BCA ASSESSMENT REPORT

**Cleanaway Recycling Facility
600 Woodstock Avenue, Rooty Hill**

Revision 1

Date: 22 December 2021

Figure 1 – Perimeter Vehicular Access per BCA C2.4.

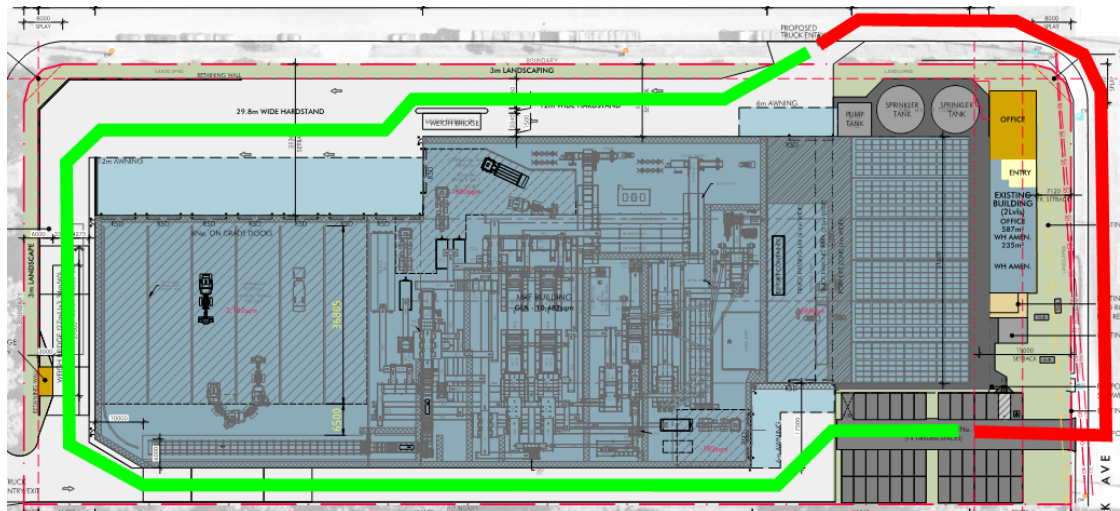
Comments: The proposed building will partially comply with the provisions of C2.4 (shown in green below), however a portion of the perimeter vehicular access is >18m from the external walls of the building (shown in red below) which is to be addressed as an Performance Solution by the Fire Safety Engineer:

Note 1: The driveways providing vehicular perimeter access must be designed with adequate loading capacities to withstand a fire truck and the gradients of the ramps should take into consideration to the FRNSW Policy 4 Vehicular Access Guideline.

Note 2: If the perimeter access paths are reduced to less than 6m in width to accommodate pedestrian egress paths per Clause D1.10 below, this will need to be documented in the Performance Solution.

Figure 2 – Proposed Fire Wall locations

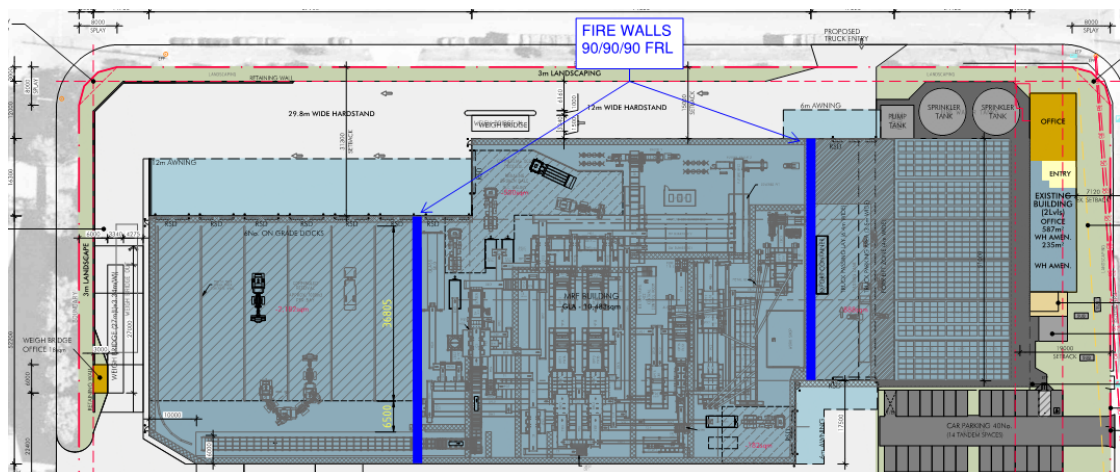
Comments: The design of the fire walls separating the Storage/Dispatch and Commingled Receivals Areas from the MRF Processing Area is required to achieve an FRL of 90/90/90 (per Spec C1.1 Table 5), and must extend up to the underside of the non-combustible roof covering, and have no structural elements/penetrations through the fire wall, that would potentially reduce the required fire resisting performance of the wall, pursuant to Clause C2.7(a) and (c) respectively. Details of the fire walls including the structural design of the roof steel are to be provided for assessment to confirm compliance.

Figure 3 – Protection of Openings in External Walls between separate Fire Compartments

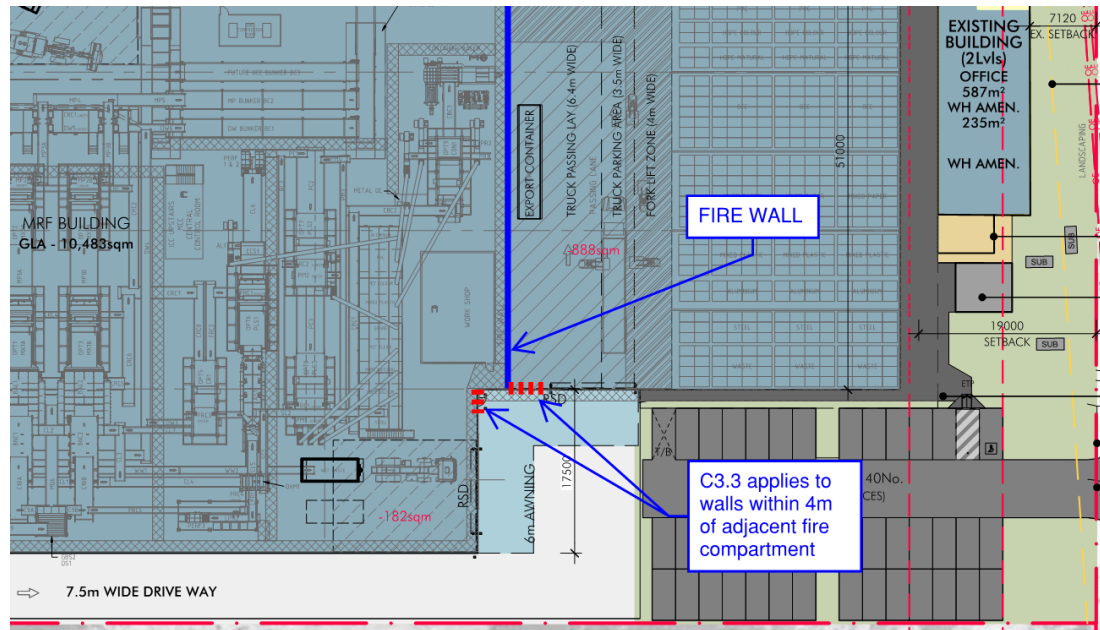
Comments: The external walls on either side of the fire wall between the MRF Processing area and the Storage/Dispatch area in the NE corner of the building are required to be protected per C3.3 as noted above – details demonstrating compliance are to be included in the CC application plans.

Figure 4 – Horizontal Exit locations

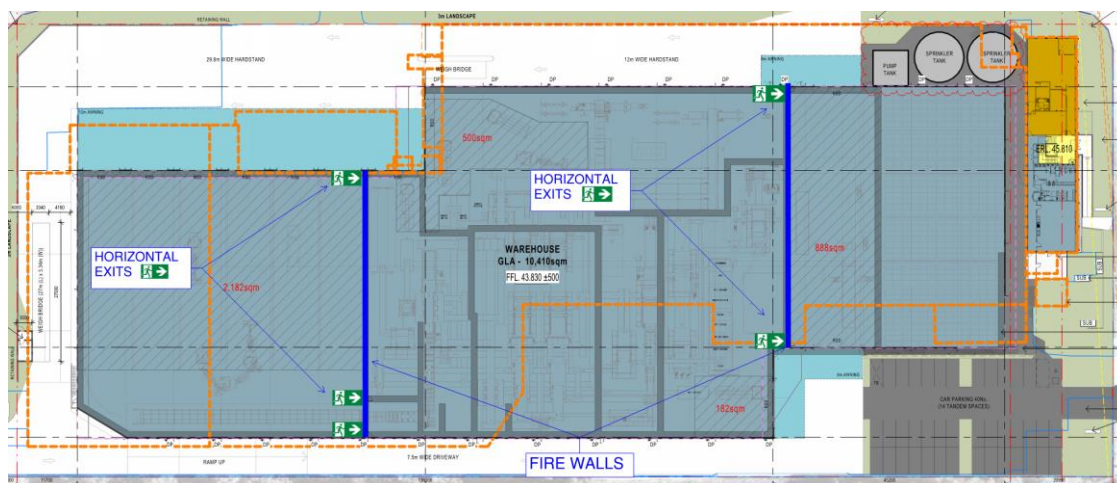
Comments: See mark-up below of the Horizontal Exit locations on each level – compliance is readily achievable with the above requirements
